Town of Rolesville, NC
Department of Planning

Comments on #SDP-26-0001 - Planning & Zoning: Site Development Plan

Application Number: #SDP-26-0001
Application Type: Site Development Plan
Date: February 27, 2026
Address: 851 S MAIN ST, ROLESVILLE
Parcel: 1758453676

SITE DEVELOPMENT PLAN (SDP-26-XX) FOR:
KIDDIE ACADEMY
LOT 4 AT WALLBROOK
851 S MAIN ST
ROLESVILLE, NORTH CAROLINA

COVER SHEET

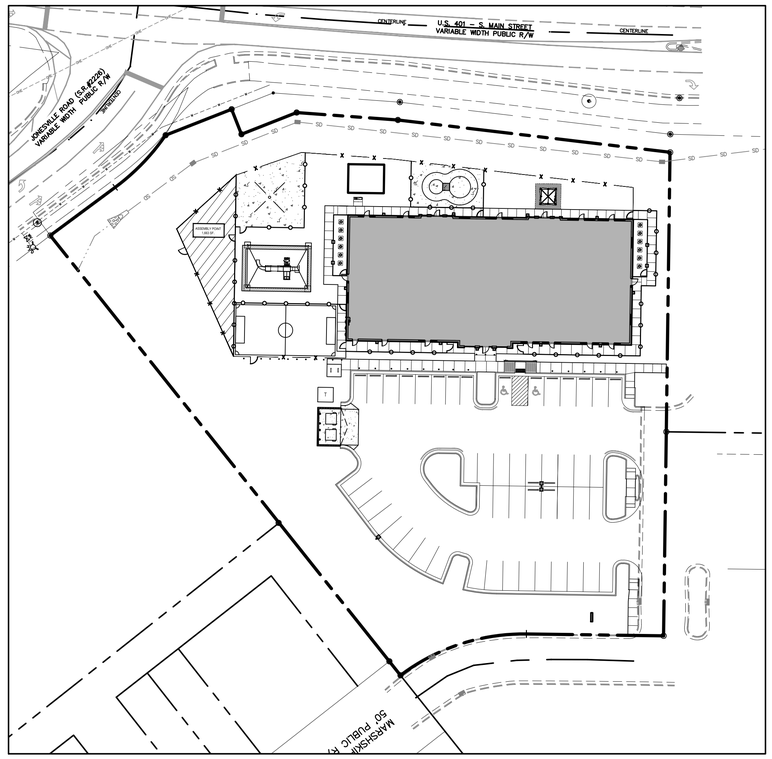
Please add PIN and date to top information bar.

Please update to the submittal # SDP-26-0001

Please add County Information

Please update building height information as it becomes available.

Please add Surveyor, Landscape Architect, mark The Site Group as the Civil Engineer, etc. if applicable.

1 FRONT ELEVATION
SCALE: 1/8" = 1'-0"

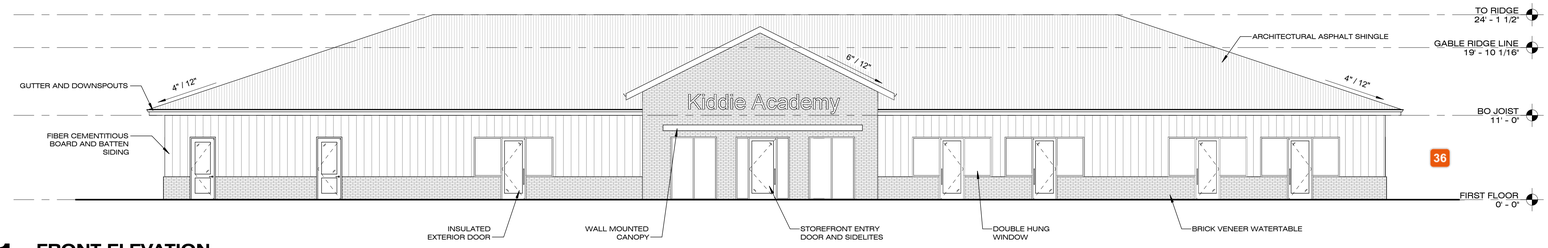
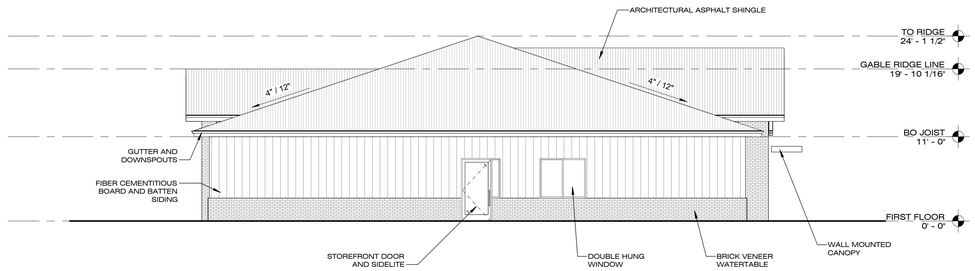
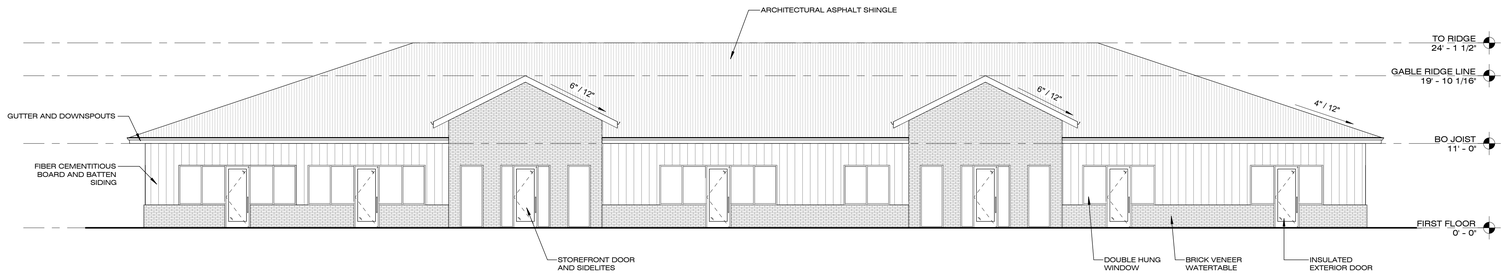
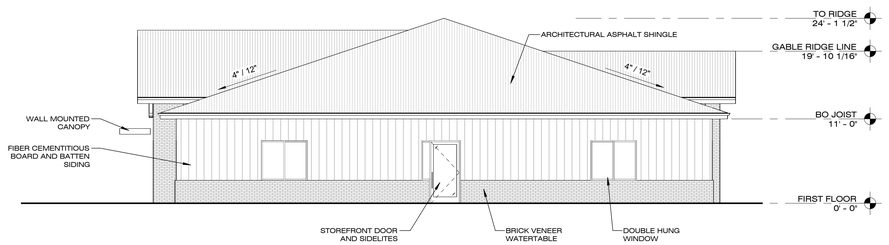
Please see LDO Section 6.8.2. Nonresidential Building Design Standards. Demonstrate compliance with item D. Standards. If it is faster/easier, you can submit a hand drawn markup of this sheet.
